Notice of Inspection with Maintenance

RE: **Lake Lure Dam**, State ID No. **RUTHE-003**
Hazard Potential: High; Rutherford County

DAM SAFETY INSPECTION REPORT

Lake Lure Dam, RUTHE-003-High

DOWNSTREAM ELEVATION

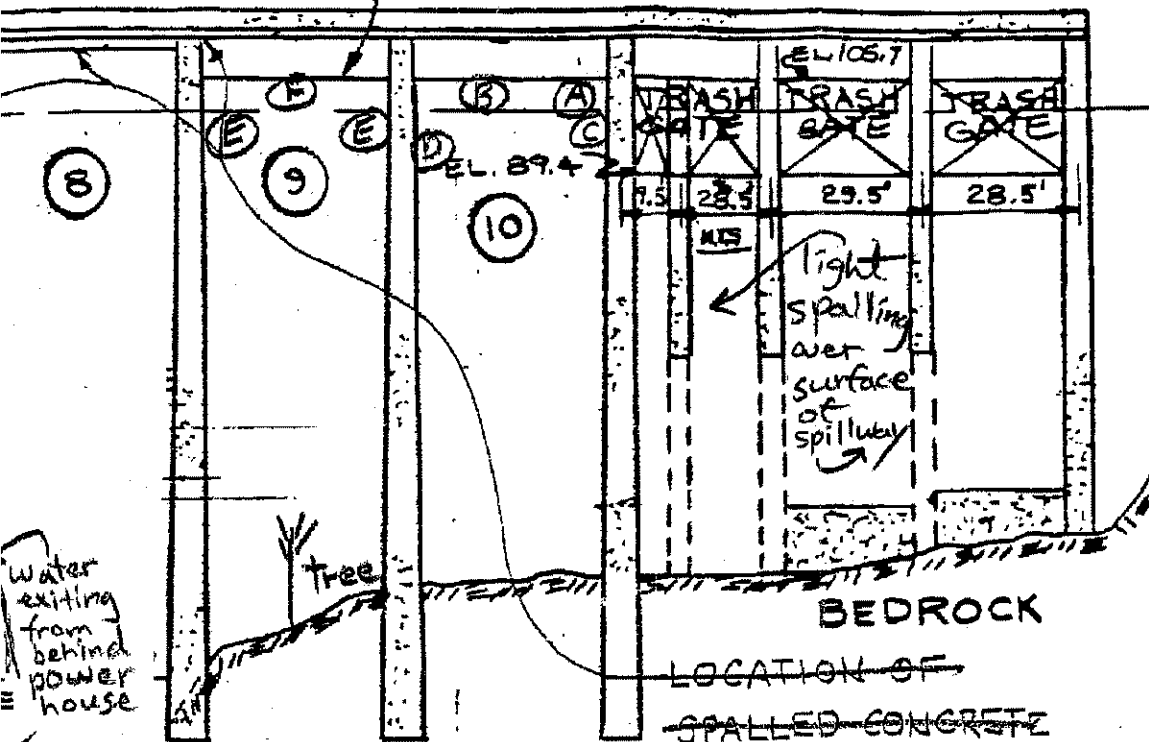
seepage between arch and buttress of about 1/2 gal/min. light seepage between Arch and buttress to the right of the bay. efflorescence bushes in the top joint.

- (A) Seepage in the cond joint from the top is more than previously noted. It is leaking near the left and center of the bay looking downstream. About 1.5 gal/min. at the left. About 2 gal/min in the center.
- (B) Bushes in 2nd joint from the top of the Arch.

LAKE LURE

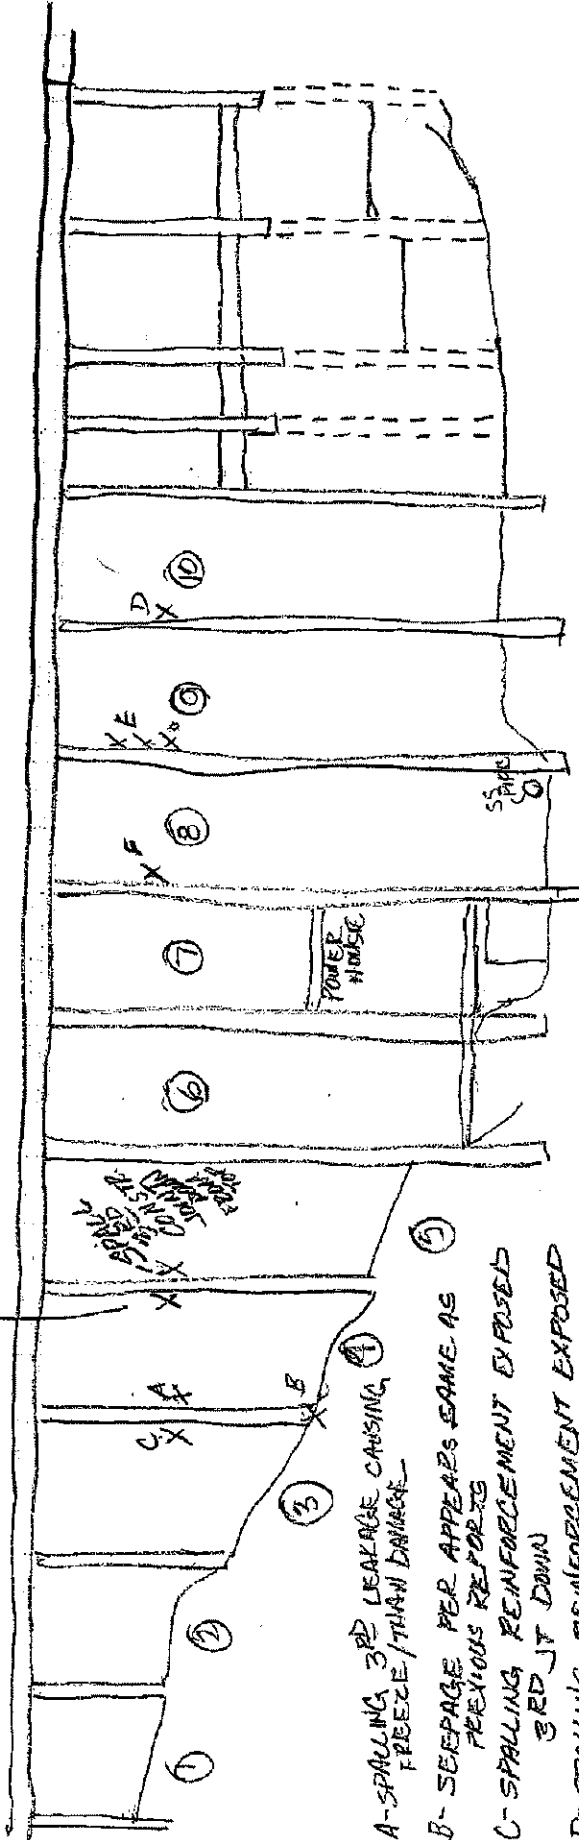
SPILL 3
3RD DOWN
FROM TOP

A-SPALLING 3RD LEAKAGE CAUSING
FREEZE/THAW DAMAGE

B-SEEPAGE PER APPEARS SAME AS
PREVIOUS REPORTS

C-SPALLING REINFORCEMENT EXPOSED
3RD JT DOWN

D-SPALLING REINFORCEMENT EXPOSED
2ND JT DOWN

E-SPALLING TOP DOWN THEN 3RD JT

F-SPALLING BETWEEN 2ND & 3RD JTS
